June 21, 2000
5928-00-20140

**SUBJECT: THREE MILE ISLAND NUCLEAR STATION, UNIT 1
OPERATING LICENSE NO. DPR-50
DOCKET NO. 50-289
LICENSE CHANGE APPLICATION (LCA) NO. 287, REVISION 1**

**TMI Unit 1 License Change Application No. 287, Revision 1
Safety Evaluation and No Significant Hazards Consideration Analysis**

FIGURE 1
MU TANK PRESSURE & LEVEL INSTRUMENTS

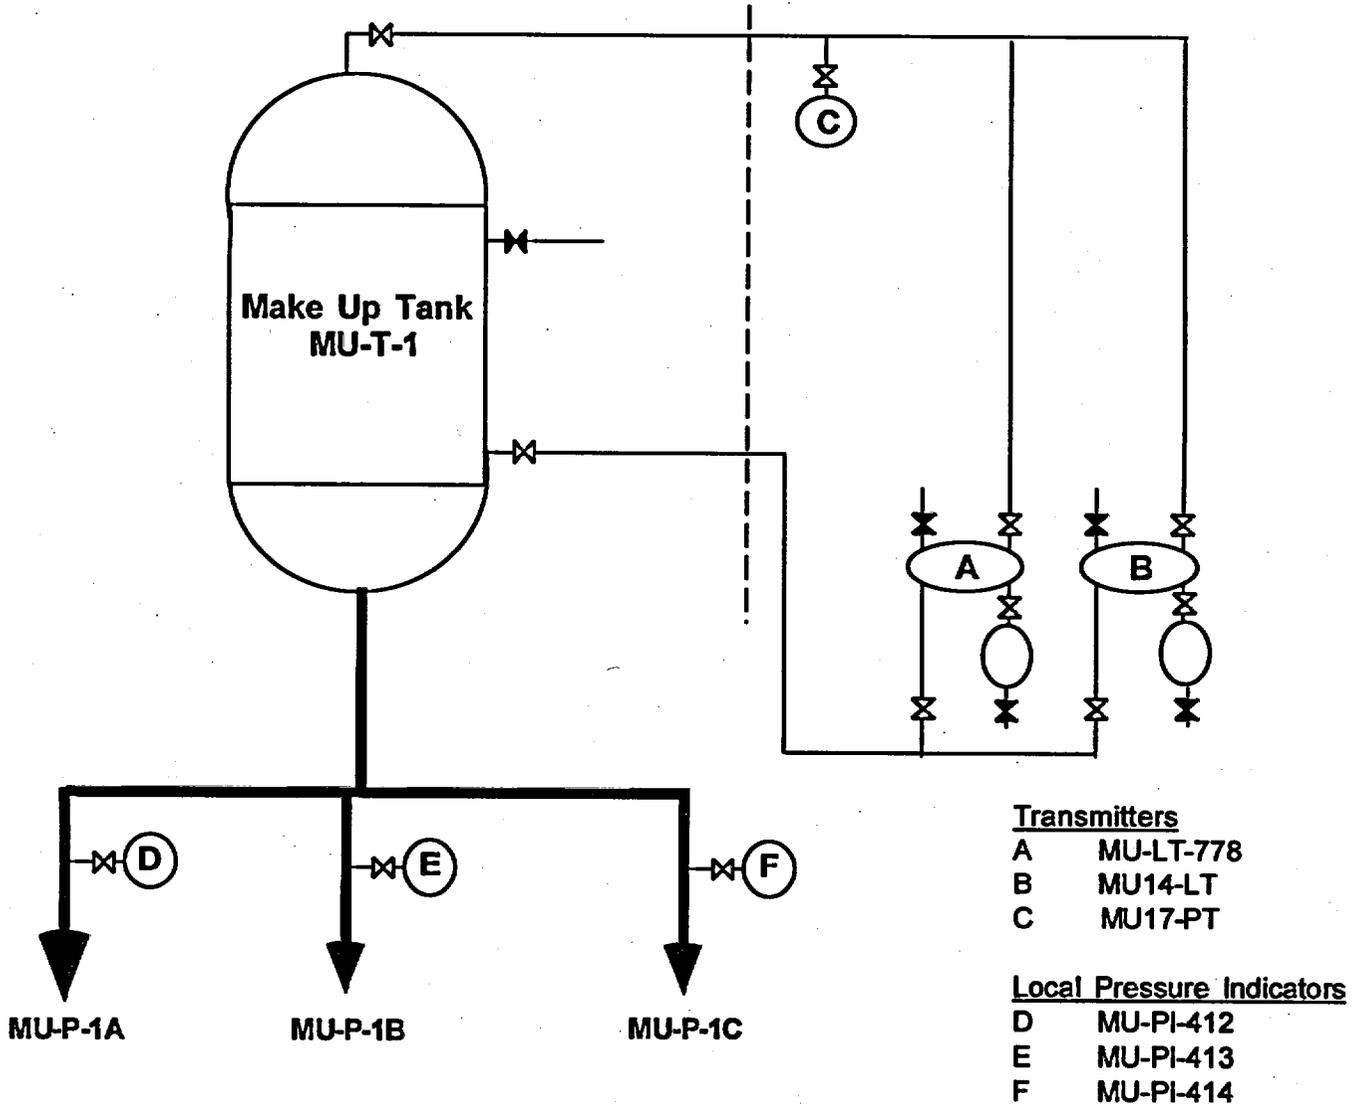
computer. The high pressure sensing line comes from a common level tap on the side of the tank (see Figure 1). The instruments are calibrated such that when the level is at the lower tap, the indicated level is zero. The low pressure sensing line comes from a single vent line on the top of the tank. The sensing line connection to each transmitter is routed to a drain pot. Any condensation in the sensing line is collected below the transmitter and does not affect the level indication. The daily operability check (Reference 20) will be performed by comparing the two control room indications.

FIGURE 3.3-1
Makeup Tank Pressure vs Level Limits
(Instrument Error NOT Included)

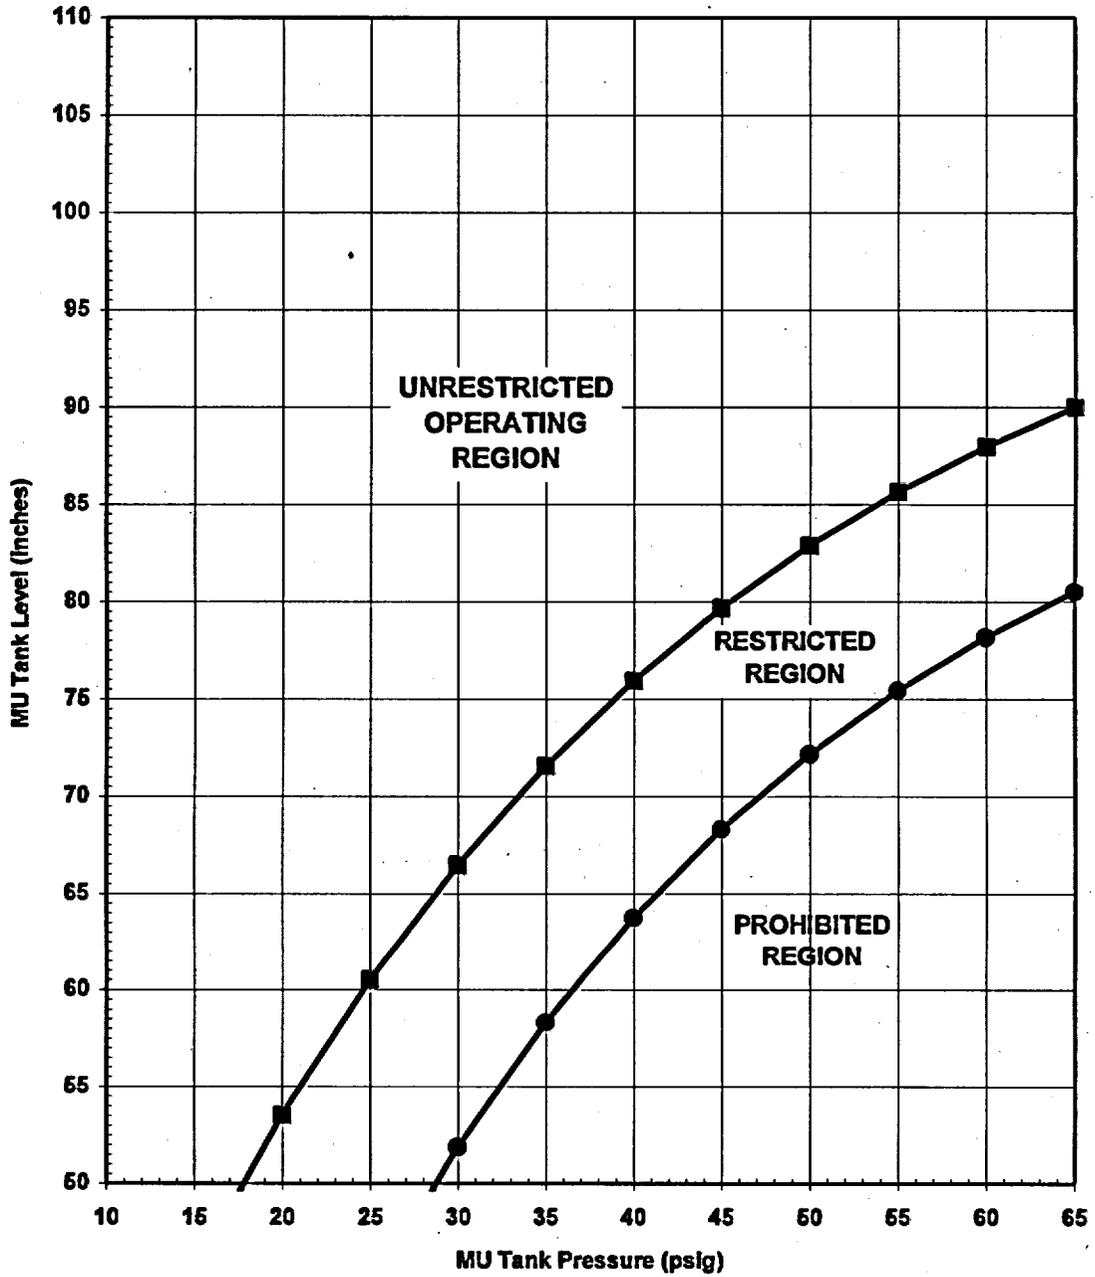
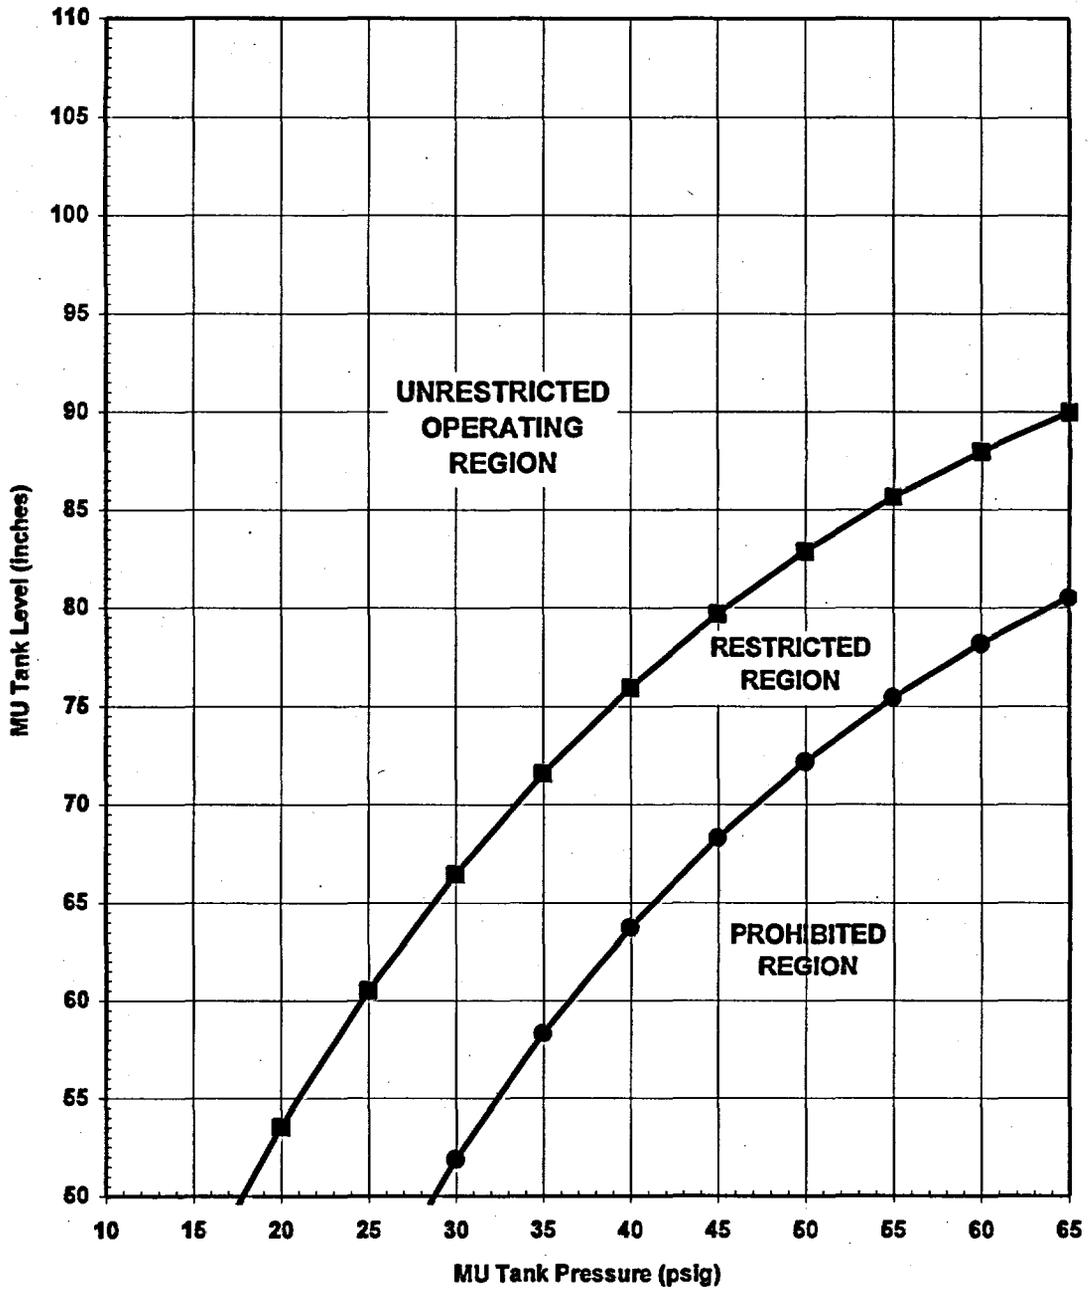
This revision of LCA No. 287 provides a new figure "Makeup Tank Pressure vs Level Limits" intended to preclude gas entrainment of the MU/HPI pumps. As a change from the original submittal of LCA No. 287:

- 1) The portion of the figure associated with Net Positive Suction Head (NPSH) has been deleted. The statements related to NPSH limits in the T.S. 3.3 Bases (page 3-23) and the supporting statements in Enclosure 1, "Safety Evaluation and No Significant Hazards Consideration Analysis," Section III.C have also been deleted.

- 2) A more restrictive region of the new figure has been added. The original submittal of LCA No. 287 had defined a single "Restricted Region" where operation within that region would be allowed for 4 hours. The addition of the "Prohibited Region" differentiates between the degraded MUT conditions where operation is limited to 72 hours from the more severely degraded MUT conditions where operation is prohibited. Specification 3.0.1 applies.

The required action time for operation outside of the "Unrestricted Operating Region" of Figure 3.3-1 has been revised from the original submittal of LCA No. 287 by providing two curves based on analysis with and without the most limiting single-failure. The two curves define three regions of the figure. Operation within the "Restricted Region" of Figure 3.3-1 assures that gas entrainment of the MU pumps will not occur without the occurrence the most limiting single failure, assuming no operator action. Inadvertent operation within the "Restricted Region" of Figure 3.3-1 requires that action be taken to restore MUT level and pressure to within the "Unrestricted Operating Region" within 72 hours or the shutdown provisions of T.S. 3.0.1 apply. A new curve has been added to Figure 3.3-1 to define a "Prohibited Region" where the HPI system function would not be maintained without operator action even without the occurrence of a single-failure. Operation within the "Prohibited Region" of Figure 3.3-1 is prohibited, requiring plant shutdown in accordance with T.S. 3.0.1.

- g. MU Tank (MUT) pressure and level shall be maintained within the Unrestricted Operating Region of Figure 3.3-1.
 - 1) With MUT conditions outside of the Unrestricted Operating Region of Figure 3.3-1, restore MUT pressure and level to within the Unrestricted Operating Region within 72 hrs. Specification 3.0.1 applies.

- 2) Operation with MUT conditions within the Prohibited Region of Figure 3.3-1 is prohibited. Specification 3.0.1 applies.

3.3.1.1 Injection Systems

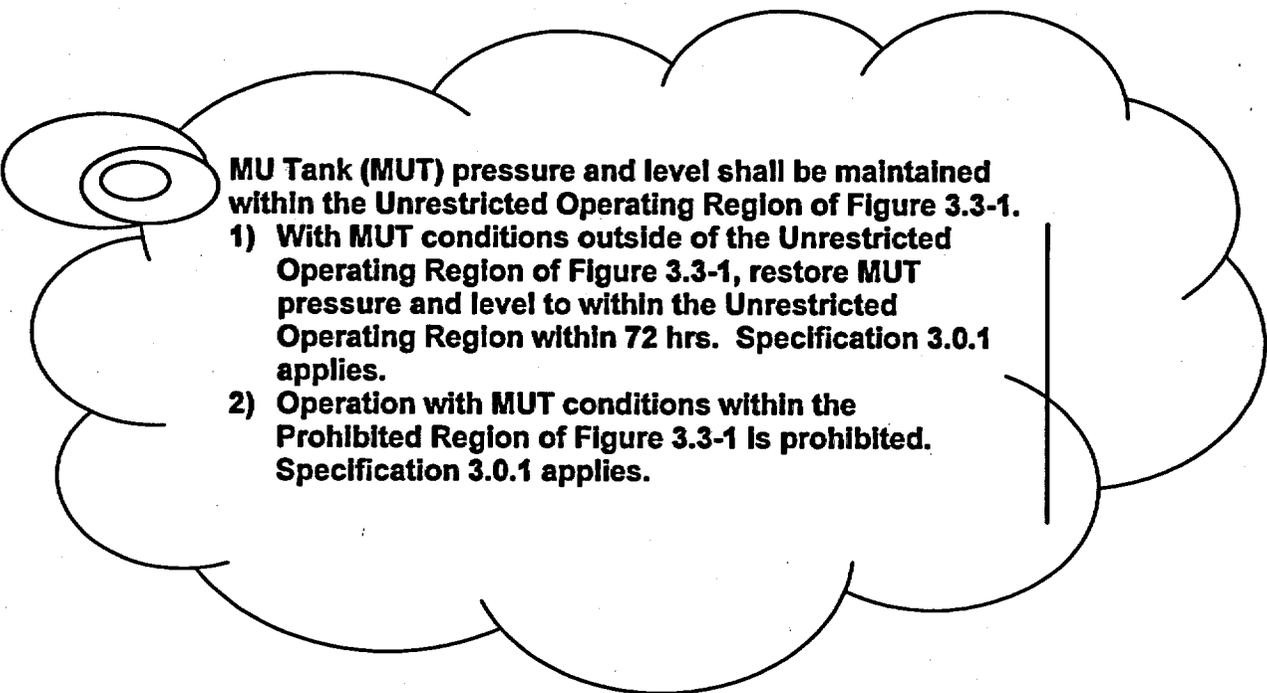
- b. Two ~~makeup~~ ^{and purification (MU)/High Pressure Injection (HPI)} pumps are ~~operable~~ ^{OPERABLE} in the engineered safeguards mode powered from independent essential buses. Specification 3.0.1 applies.
